**Quality Audit Report
Proposed Part 8 Residential
Development, Lamb's Cross, Dublin 18**

Client:	Malone O'Regan Consulting Engineers
Document No:	231860-ORS-XX-XX-RP-TR-13g-009

This report documents the findings of a Stage 1 Road Safety Audit (RSA) carried out with respect to a Part 8 proposal for the development of 37 no. residential units at Lamb's Cross, Dublin 18 situated at the junction of Sandyford Road and Hillcrest Road.

Problem No.1: Sightlines Encroaching Neighbouring Property Wall

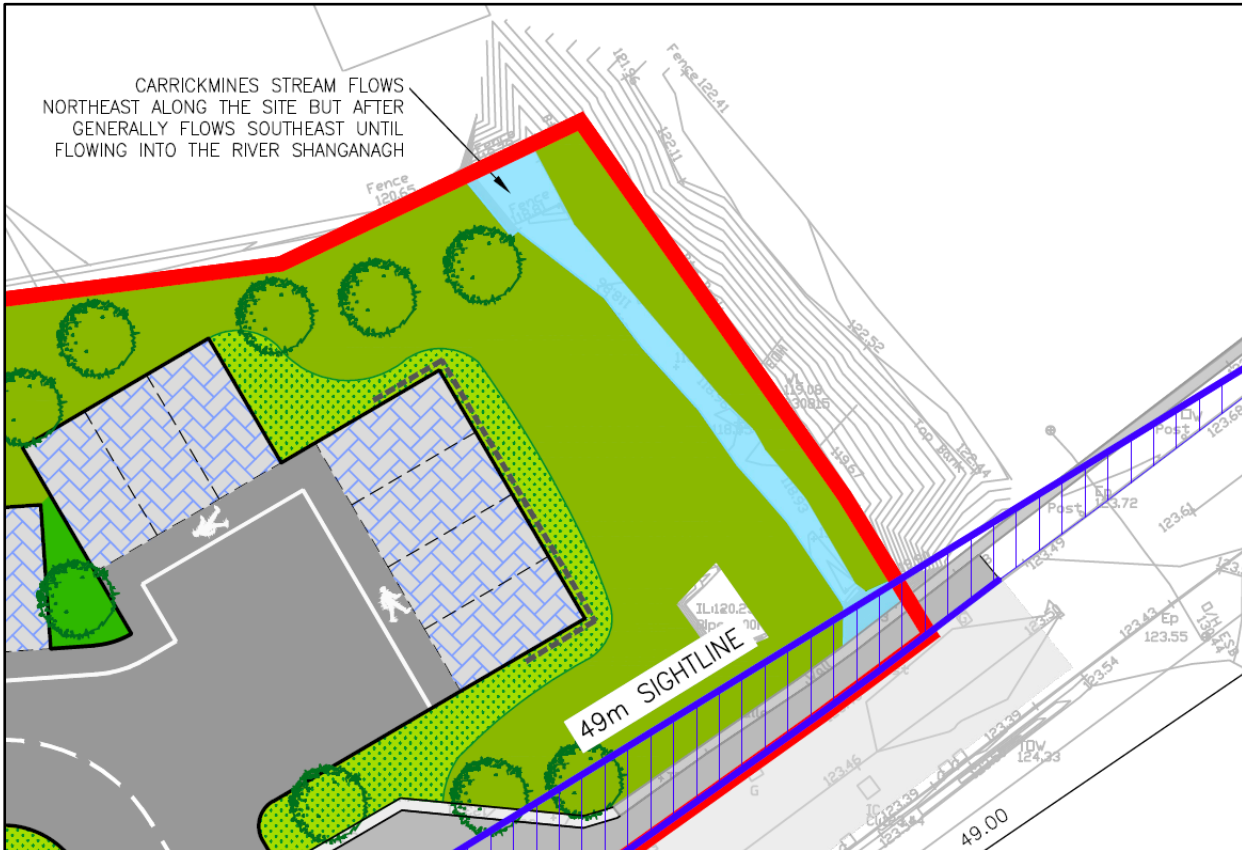
Location: Main Access

The audit team note from the drawings provided that the sightlines at the main access appear to encroach over the neighbouring boundary wall which could restrict visibility for exiting vehicles. This could potentially result in potential collisions with vehicles on the mainline due to unsafe exits.

The design team should ensure that the sightlines from the development are not restricted by existing boundary walls.

Problem No.3: Solid Centreline

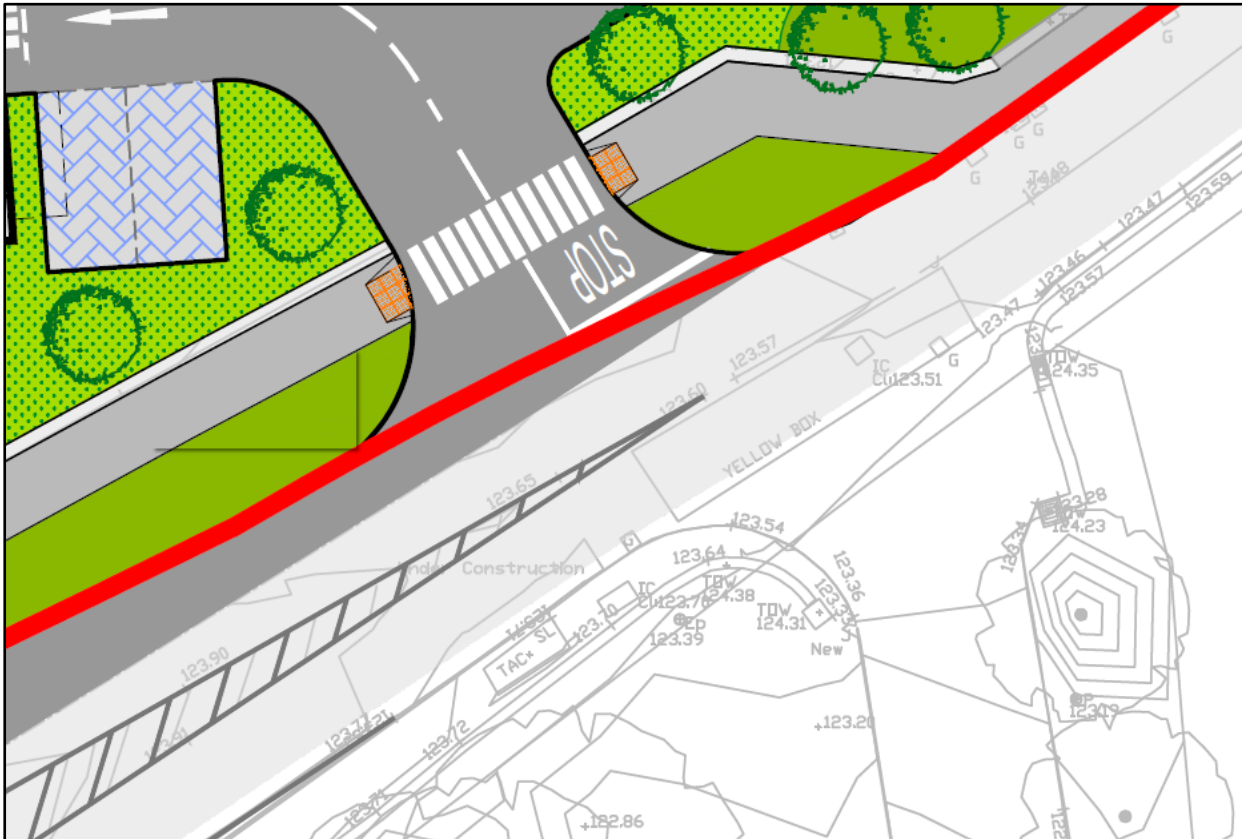
Location: Entrance at Hillcrest Road

The audit team note from the site visit that there is an existing solid centreline on Hillcrest Road which would indicate that vehicles approaching from the east are not permitted to cross the road/centreline to gain access to the development. This could result in potential confusion among motorists which could lead to unsafe manoeuvres.

The design team should ensure that the centreline is dashed or has a break at the access point to allow vehicles to cross.

Problem No.4: Existing Pedestrian Crossing

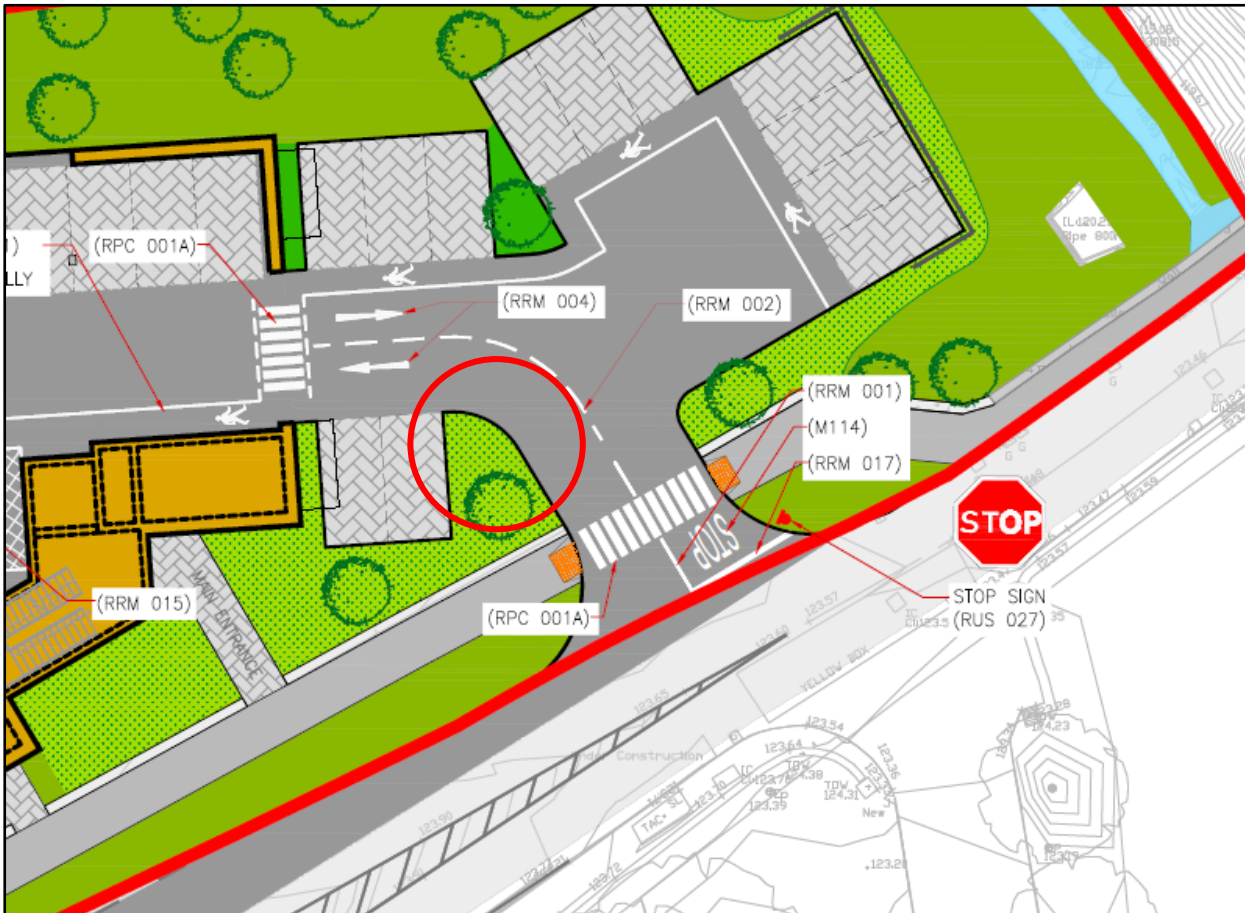
Location: Entrance at Hillcrest Road

The audit team note from the site visit that there is an existing pedestrian crossing and tactile paving in the vicinity of the carpark access into the development. The design allows for the northern crossing to be removed, however there is not detail on how the southern crossing is to be dealt with. There is a risk that visually impaired users approaching from the south will use the existing crossing and become disoriented when they do not meet a corresponding crossing facility on the opposite side of the road.

The design team should ensure the existing crossing is removed on both sides.

Problem No.6: Restricted Accessible Spaces

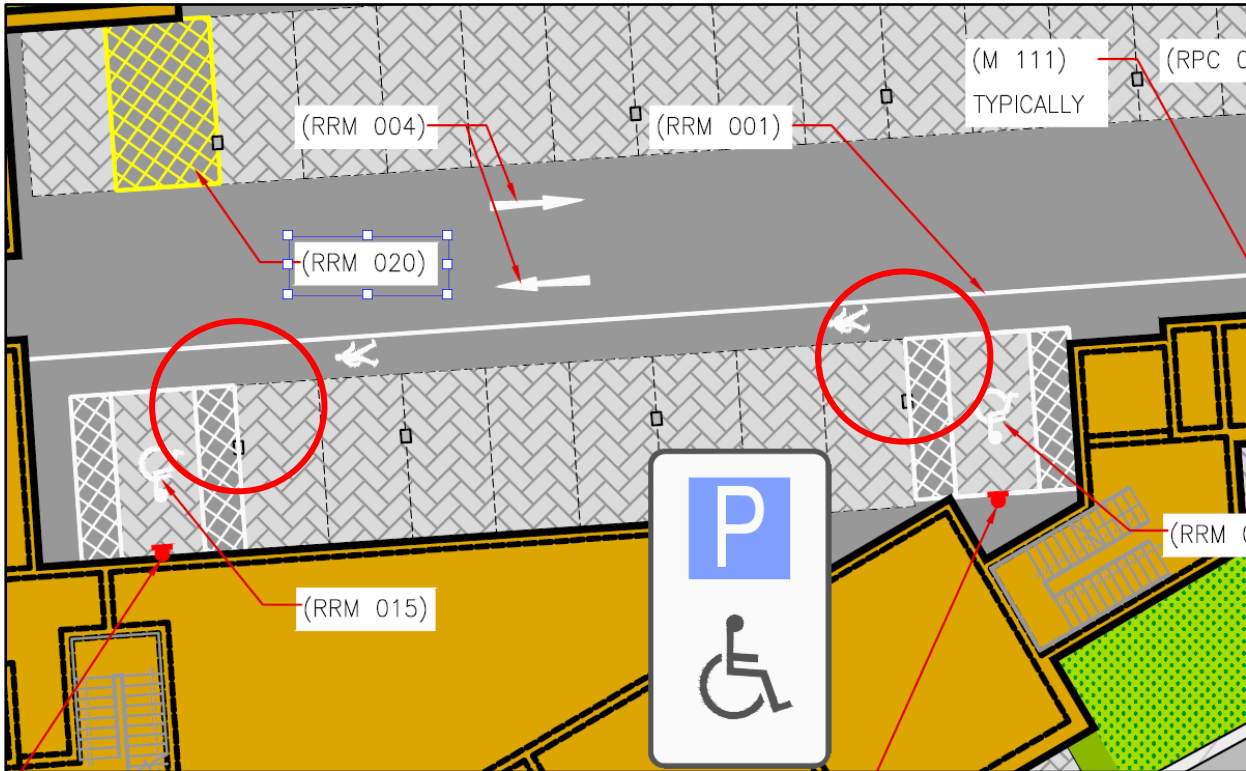
Location: Under Croft Carpark Area

The audit team note from the drawings that there are columns proposed next to the accessible spaces which could potentially restrict the movement for vulnerable users.

The design team should ensure that the columns do not restrict the movement of vulnerable users.
